Update on Water Ingestion Problem on M1 Tank.

SUBJECT: Water Ingestion in the M1

MODEL (S): MIEI MI IPMI		CHANGE REQUEST				NUMBER L3626B		
ENGINEERING CONTRACT NUMBER:						SHEET 1 OF 14		
PRODUCTION INCORPORATION AT BLOCK		PRIORITY U	CATEGORY D	CLASS I	DATE 12 OCT 84	COMMAND: ARRADCOM <input type="checkbox"/> TACOM <input checked="" type="checkbox"/> GDLS <input type="checkbox"/> OTHERS _____		
RECOMMENDED EFFECTIVITY BY SERIAL NUMBER		ACTION <input type="checkbox"/> ECP <input type="checkbox"/> ERR <input type="checkbox"/> RFD <input type="checkbox"/> RFW <input type="checkbox"/> MFR MOD <input checked="" type="checkbox"/> FIELD MOD				DOD-STD-480 REQ'D <input type="checkbox"/> YES <input checked="" type="checkbox"/> NO		
RECOMMENDED RETROFIT <input type="checkbox"/> YES <input checked="" type="checkbox"/> NO		TITLE OF CHANGE AIR BOX DRIP RAIL AND BAFFLE KIT FOR WATER ELIMINATION				REV.	DEPT. MGR.	DATE
<input type="checkbox"/> JUSTIFICATION STATEMENT FOR YES RECOMMENDATION ATTACHED						REV.	DEPT. MGR.	DATE

Title of Kit: AIR BOX Drip Rail AND Baffle KIT FOR WATER ELIMINATION	Date 12 OCT 84	RFC Number -B
---	-------------------	------------------

FIGURE 188. TOP DECK COVERS, AIR BOX, AND RELATED PARTS.

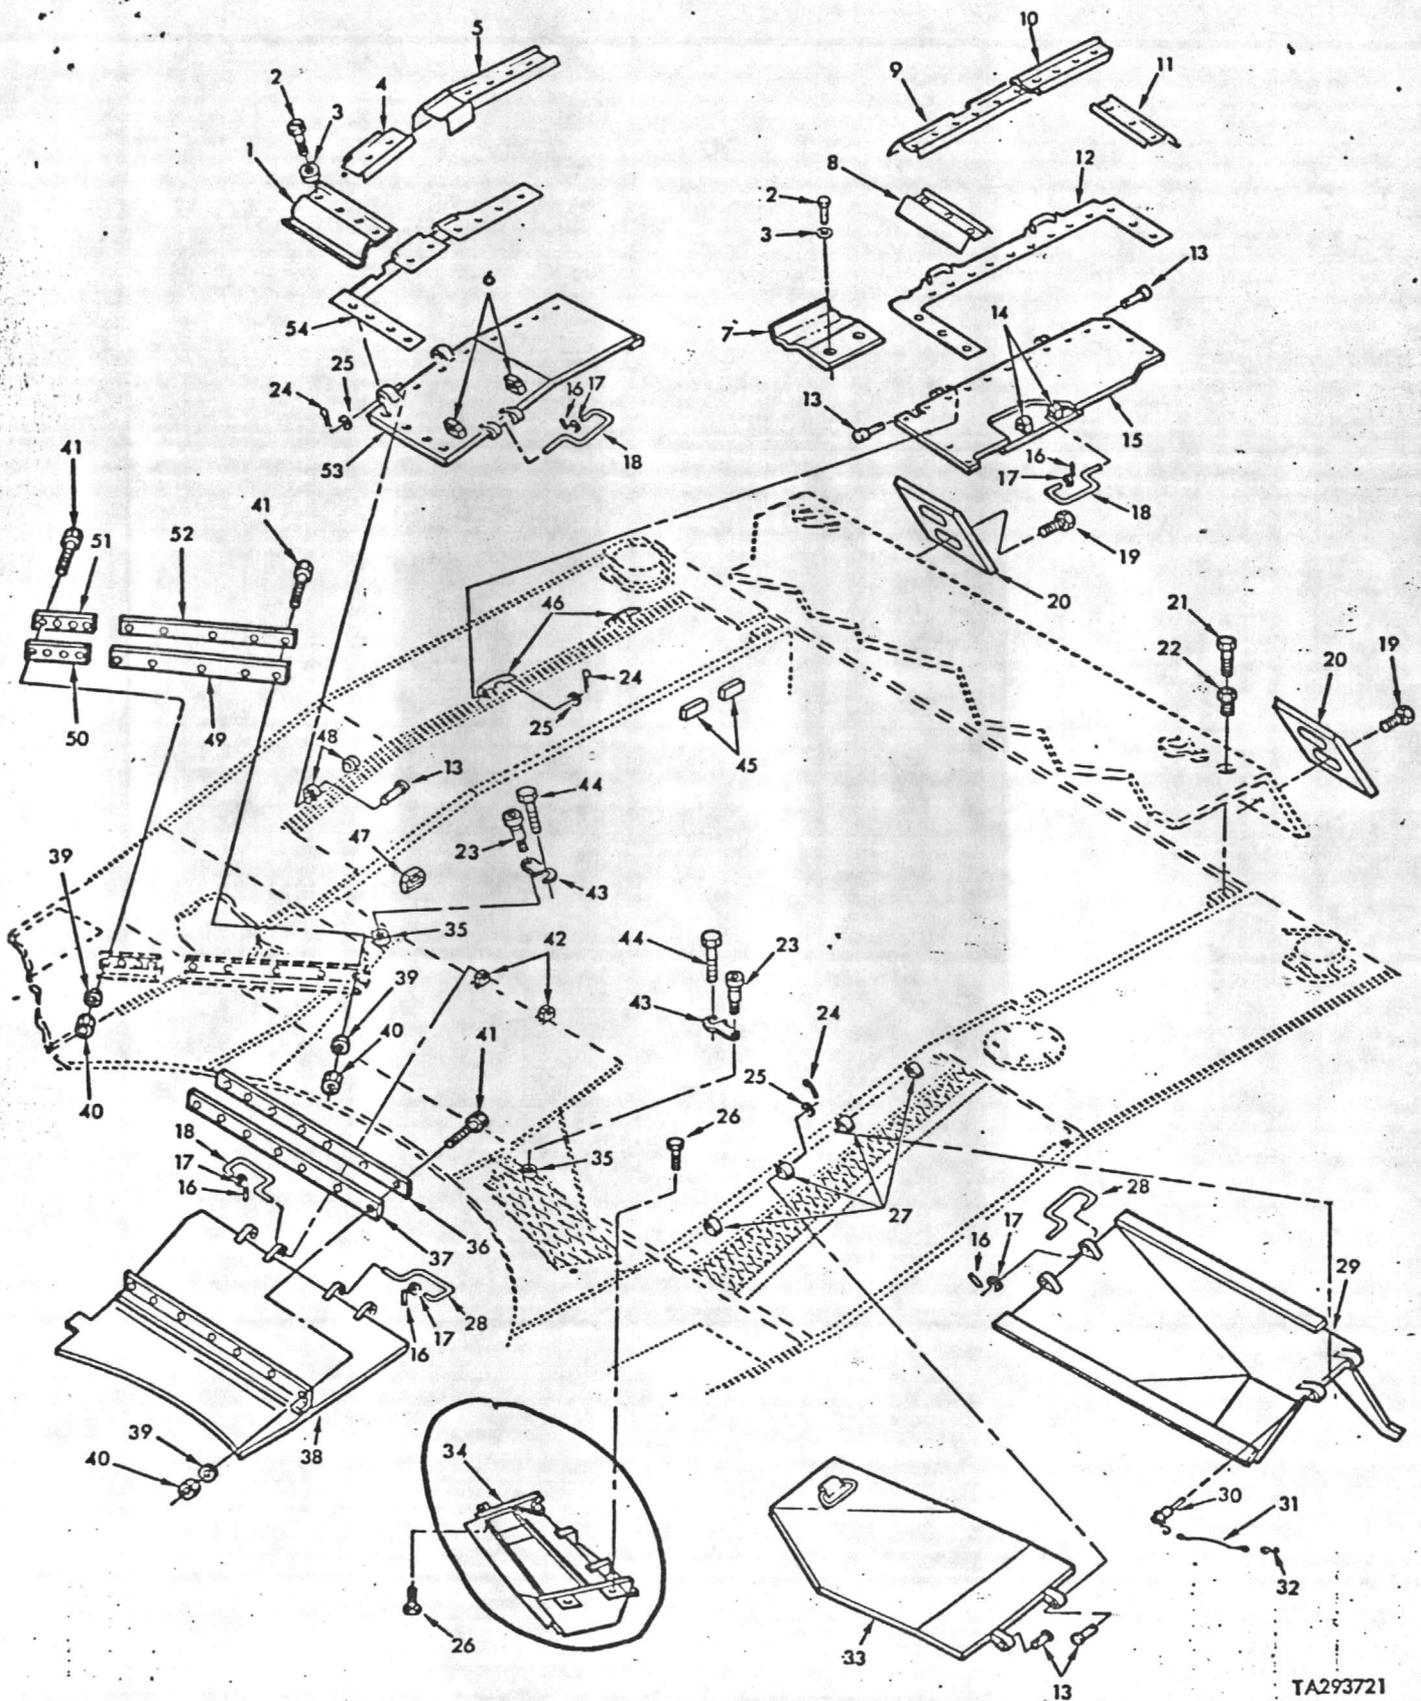
2. In both cases of 2/8 and 1/7, I strongly feel that water was ingested, primarily, through the air inlet grill located above the air box and forward of the precleaner doors (item 34, Encl 1). Extensive checks by both 2/8 and 1/7 indicate this is the case. To further substantiate this, ECP L3626-B (Encl 7) has been designed for the M1A1 (I am not sure if it is approved or not). This ECP adds a "drip rail" to channel water away from the precleaner as it comes in through the air inlet grill.

(3) The major contributor to water ingestion is water flowing into the precleaner through the air inlet grill located above the air box and forward of the precleaner doors.

(4) ECP L3626-B adds a "drip rail" which directs water from the precleaner.

FIG 5

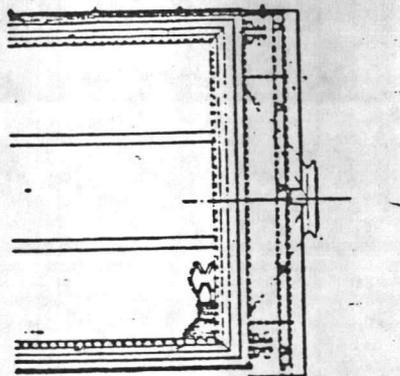
AUXILIARY SYS		THE PRESENT AIR BOX SEAL ARRANGEMENT ALLOWS WATER TO ENTER THE AIR BOX DURING RAINSTORMS AND VEHICLE WASHING						
ELECTRICAL		SOURCE OF CHANGE:						
FIRE CONTROL		WD JYZD1077		WIR _____		RFD/RFW _____		
OPTICAL SIGHTING		OTHER <input type="checkbox"/> COPIES ATTACHED						
CONTROL SYSTEMS		ENGINEERING COMMENTS/HARDWARE DISPOSITION:						
MECHANICAL/HYD		INTERCHANGABILITY AFFECTED <input type="checkbox"/> YES <input type="checkbox"/> NO						
POWERPACK		ORIGINATOR WM. FORSYTHE		DATE 12 OCT 84		REVIEWING ENGR _____ DATE _____		
AIR HANDLING/COOLING		DEPT. MANAGER _____		DATE _____		DEPT. MANAGER _____ DATE _____		
ENGINE		CCB DISPOSITION <input type="checkbox"/> APPROVED <input type="checkbox"/> REJECTED				PROGRAM MANAGER _____ DATE _____		
TRANSMISSION		AFFECT ON WEIGHT <input type="checkbox"/> INCR <input type="checkbox"/> DECR <input type="checkbox"/> NONE				ADVANCED RELEASED _____ DATE _____

Title of Kit: AIR BOX DRIP RAIS	Date 12 OCT 84	RFC Number -B
<p>Modification Details: (Special Skills)</p> <ol style="list-style-type: none"><li>10. REPLACE RIGHT SIDE SEAL WITH NEW SEAL PIN 1234423.</li><li>11. REMOVE SEAL PIN 12287783 AND RETAINER PIN 12287787 FROM PRECLEANER PIN 12287845 SEE FIG 5</li><li>12. REPLACE BACK PRECLEANER SEAL WITH NEW BRACKET PIN 1234424, NEW SEAL PIN 12344184 AND NEW RETAINER PIN 12344177 PER FIG 6</li><li>13. REASSEMBLE VEHICLE PER ATTACHMENT "B"</li><li>14. COMPLETE ECAR AND RETURN</li></ol> <p>* INSPECTION NOTE: INSPECTION TO CHECK WELDS AND COMPLETION OF MOD INSTRUCTION</p>
